ADDENDUM #4

Bid 19C14, Rock Creek School Replacement Project <u>REVISED DUE DATE & TIME:</u> FCPS Main Lobby, Wednesday, August 7, 2019, prior to and time stamped no later than 2:00 P.M.

Project: Rock Creek School Replacement

ADDENDUM NO. 4

M201D

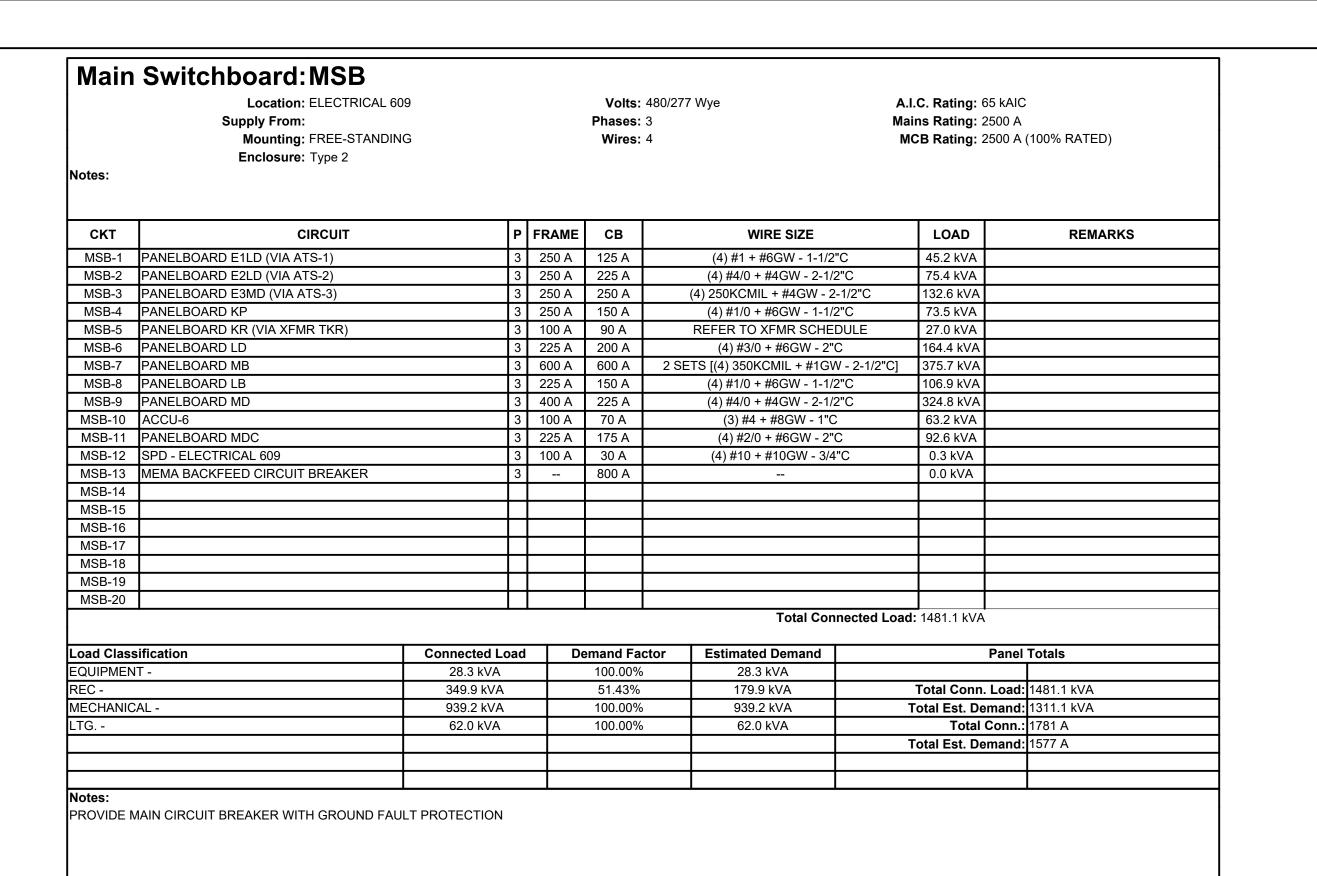
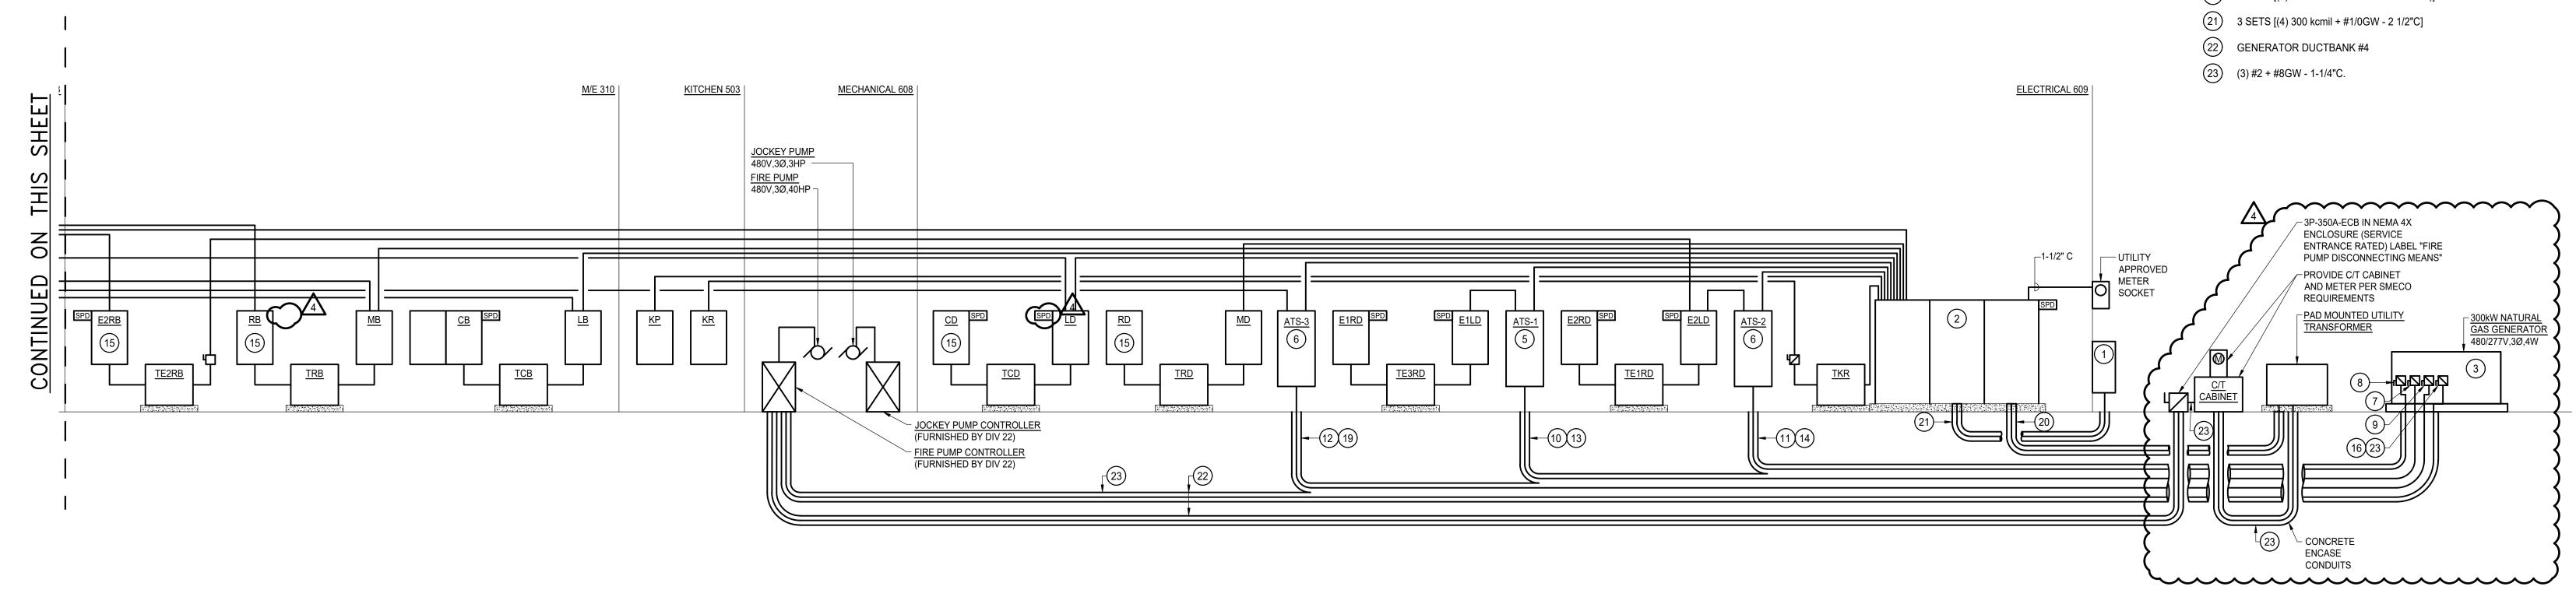
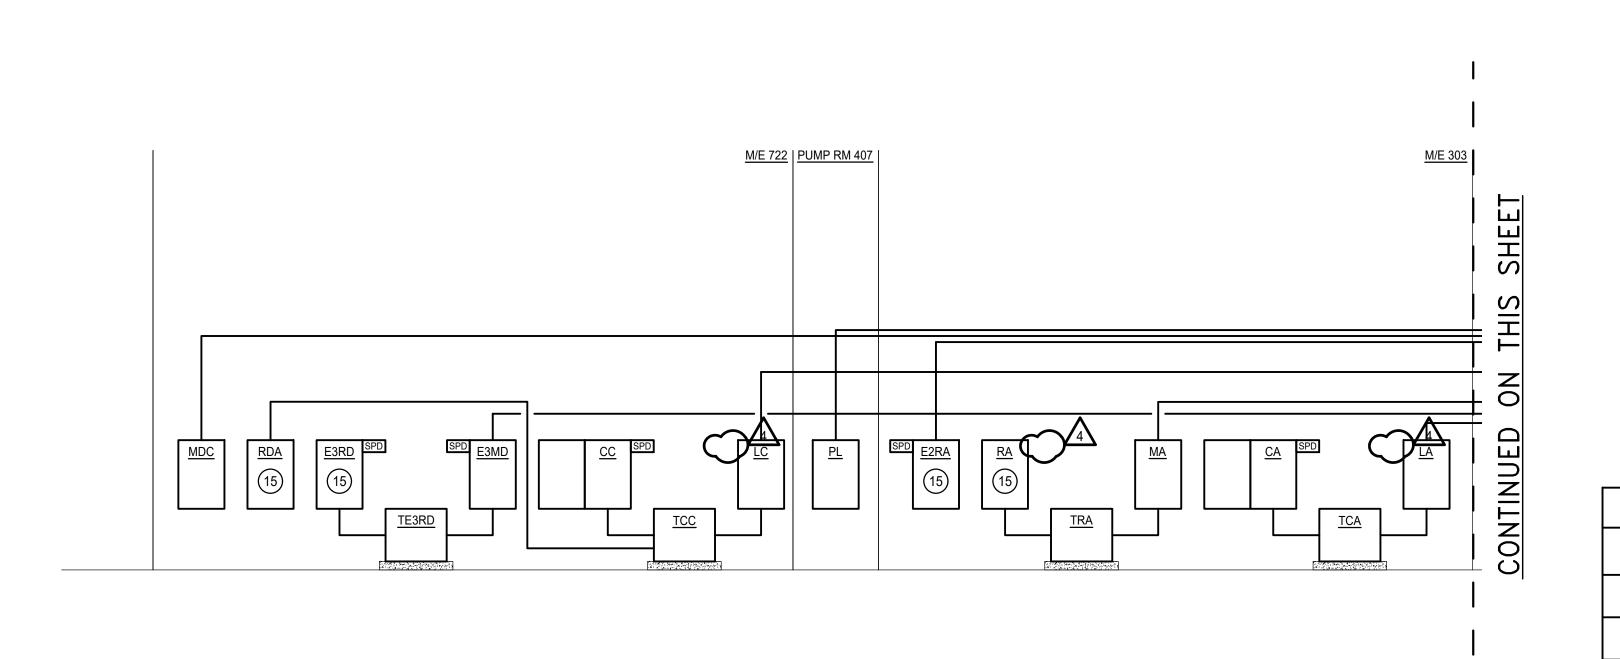
ADD – ADD Drawing note 32: 14"x14" OED W/1/2" MESH BIRDSCREEN.
